## Quick Reference Guide (QRG) #6

# Wiring changes required when replacing a 1<sup>st</sup> Generation Ignition Lock Motor that has 5 wires with a 2<sup>nd</sup> Generation Ignition Lock Motor that has 3 wires

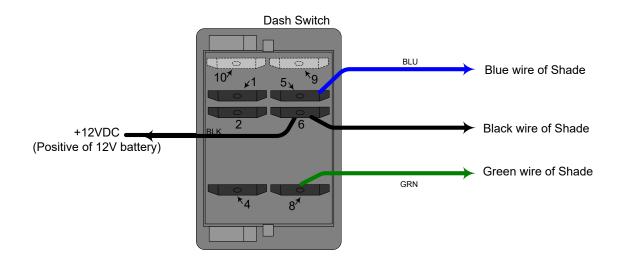
- The head of motor 4270P (2<sup>nd</sup> Gen.) is 1/8" thicker than the head of motor 4270 (1<sup>st</sup> Gen.) Illustration (1)
- If you are replacing both motors on a Double Roller Shade (DRS), no special changes on the head rail tubes are required, except that you need to move one side mounting bracket on either the left or the right side 1/8" further out to accommodate the new slightly longer motor heads.

- ➤ If only one of the two 1<sup>st</sup> Generation motors on a DRS shade is defective and you do not want to replace both motors with 2<sup>nd</sup> Generation motors, the aluminum tube housing the replacement motor needs to be cut down with a fine-toothed metal saw by 1/8" to match the same overall width of the other tube so both will fit back into the side brackets.

### Wiring Diagram of 2<sup>nd</sup> Generation Ignition-Lock Motor 4270P (Single Shade)

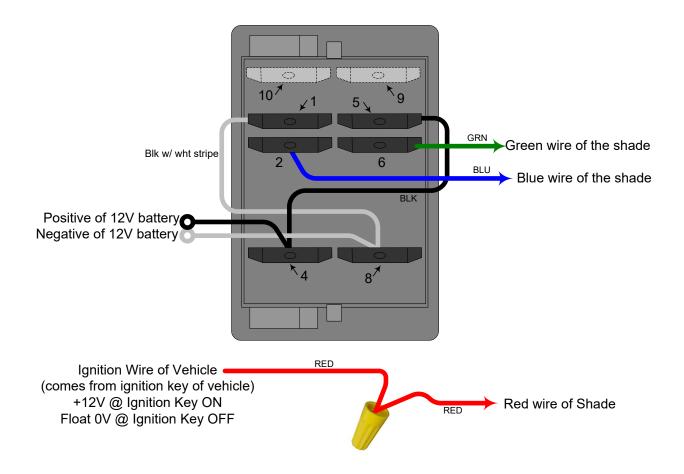
- ➤ Because of the change from 5 wires on the 1<sup>st</sup> Generation motor to 3 wires on the 2<sup>nd</sup> Generation motor, the wiring on the dashboard switch will have to be changed as shown in the wiring schematics below. The 2 extra wires no longer used will have to be capped off.
